11 December 2019

RE: SANCROX QUARRY EXPANSION PROJECT – PROJECT NUMBER – SSD-7293

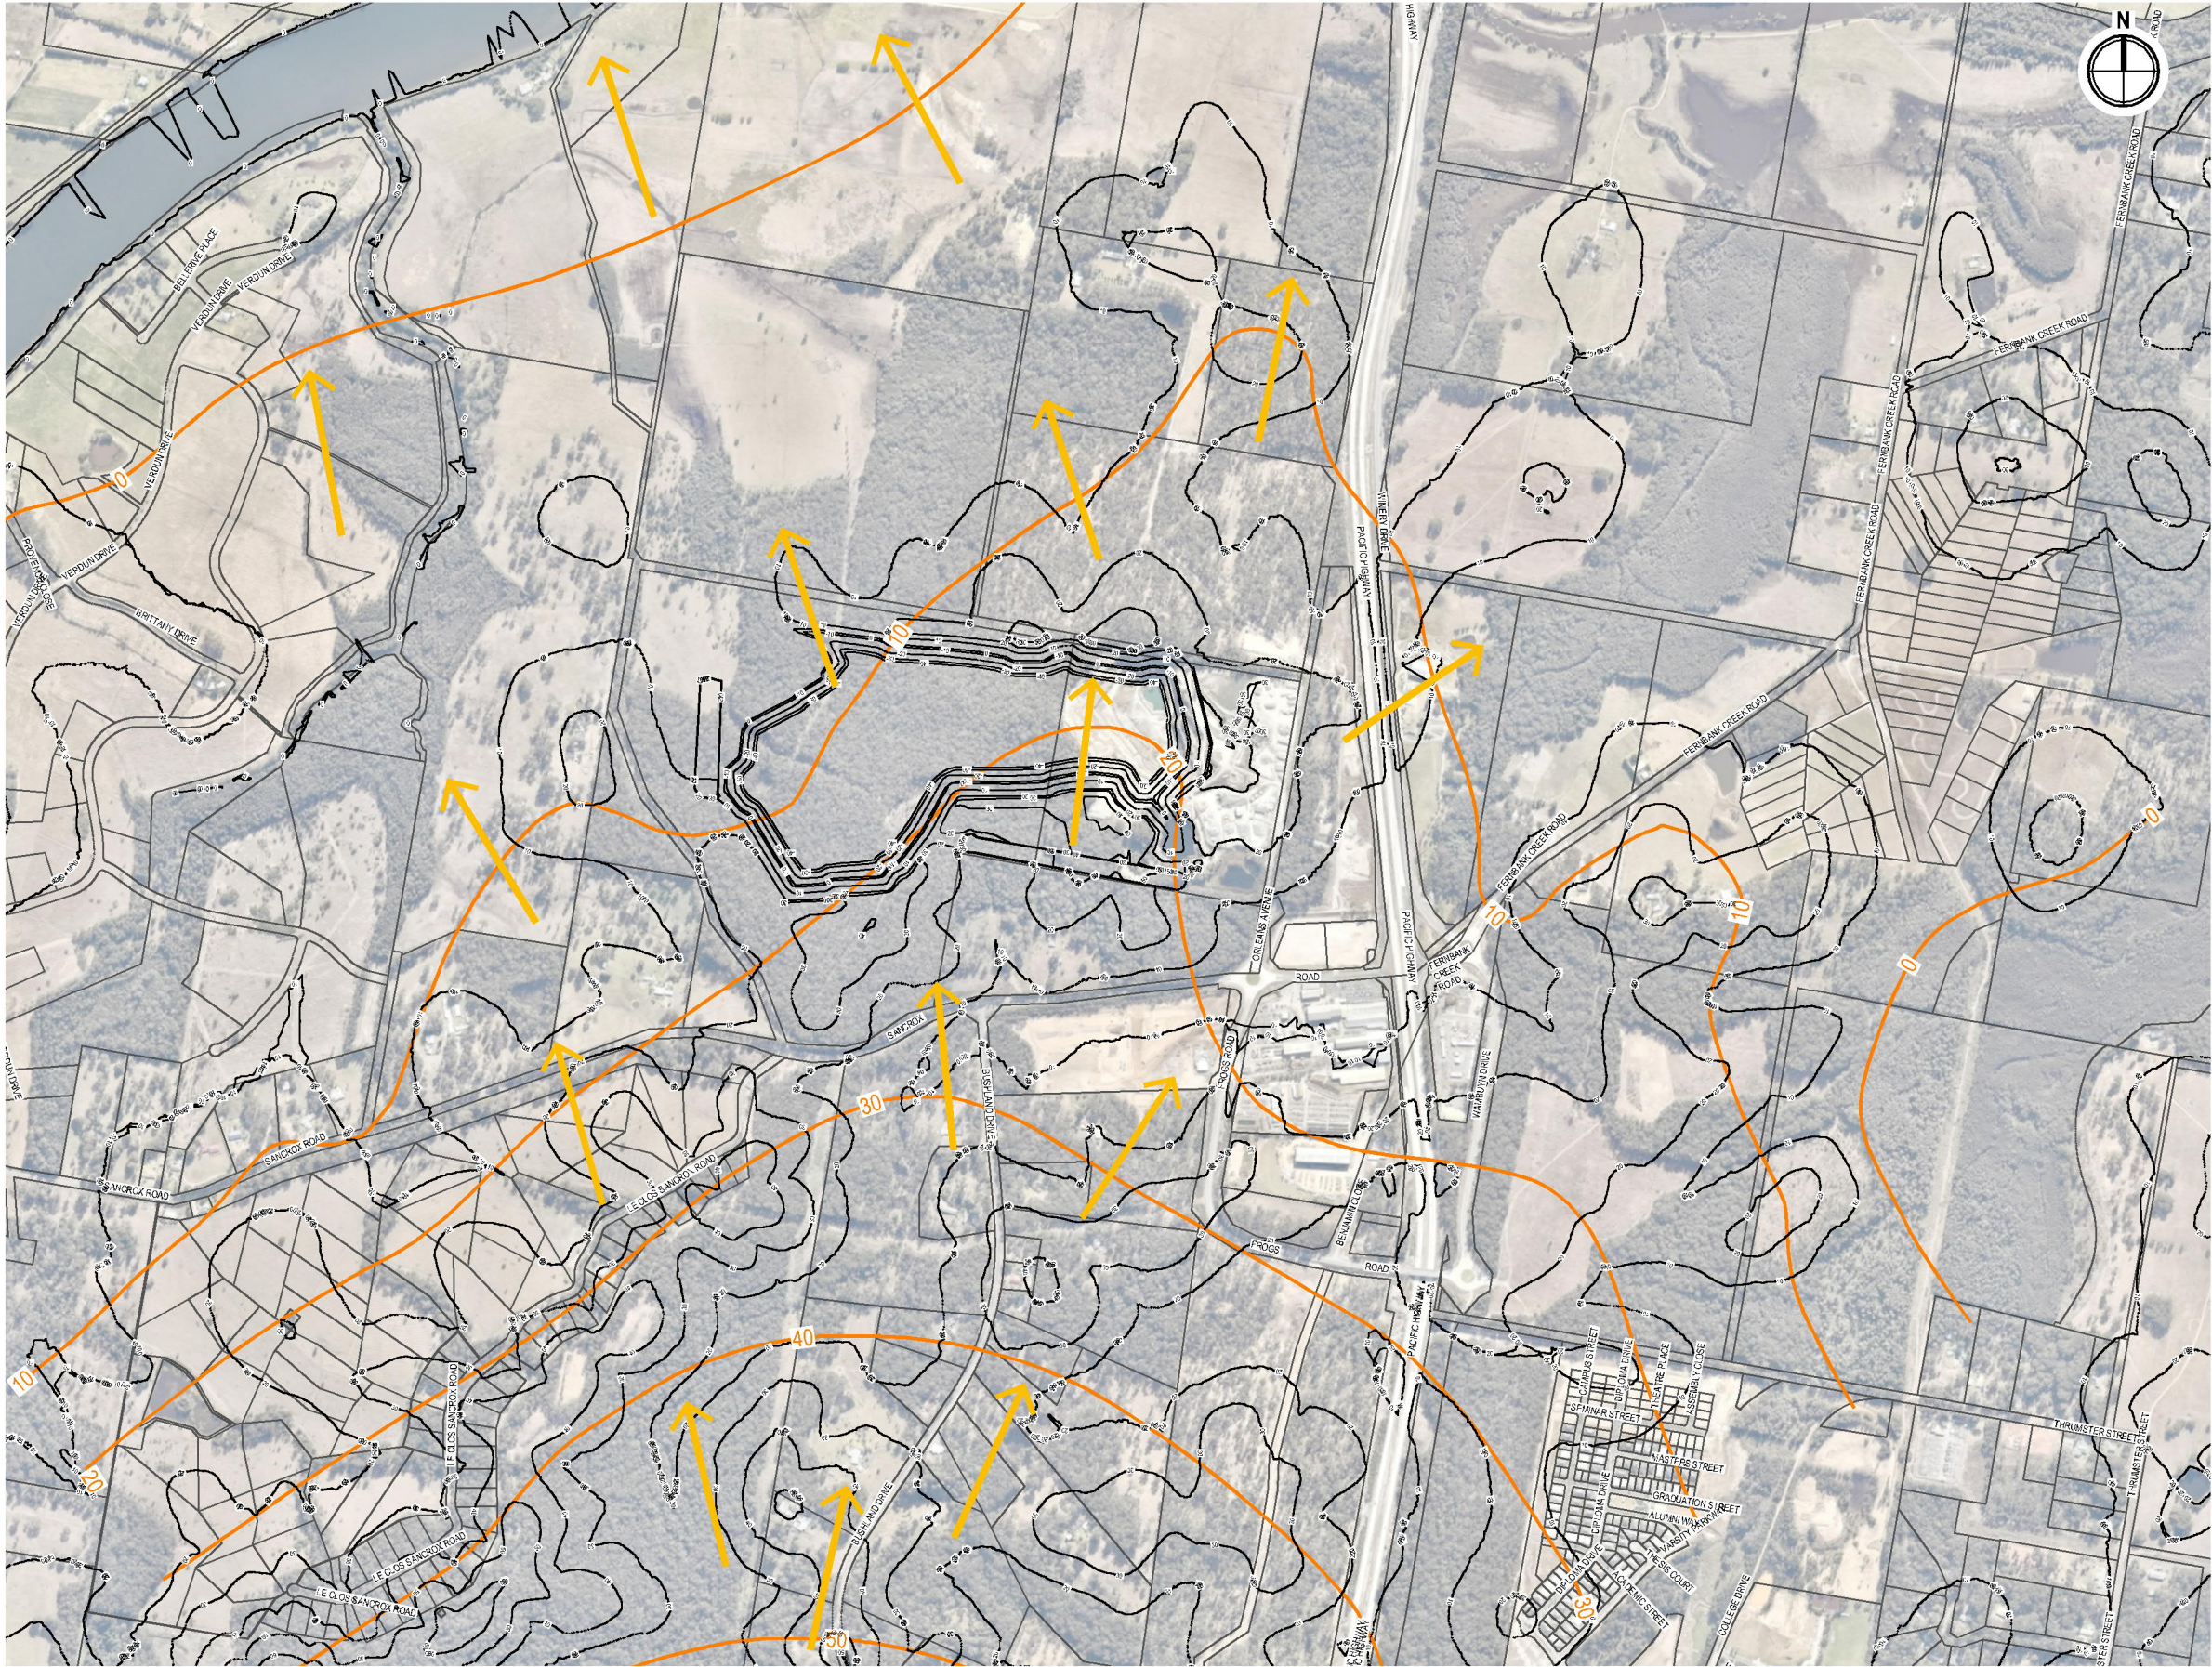
- An analysis of the expected equipotentials following the excavation of the quarry based on the information provided within figures 5.4 and 5.5 of the report indicates that the expanded quarry will act as a localised sump for groundwater flows. The plan showing the existing equipotentials indicates the groundwater generally moves from South to North towards the Hastings River, however, when taking into account the expected drawdown as shown within figure 5.5 of the report and generating new equipotentials for the post development case, groundwater flows are significantly modified to be drawn towards the quarry. (Refer **Attachment 6**)

- In extreme cases, groundwater flows appear to reverse in the area to the north and northwest of the quarry resulting in groundwater flows moving southwards from the Hastings River towards the quarry excavation.

- The report does not provide any discussion on the impacts of the reversing of groundwater flows. The potential risk that saltwater from the Hastings River may be drawn into the groundwater towards the quarry excavation must be quantified.
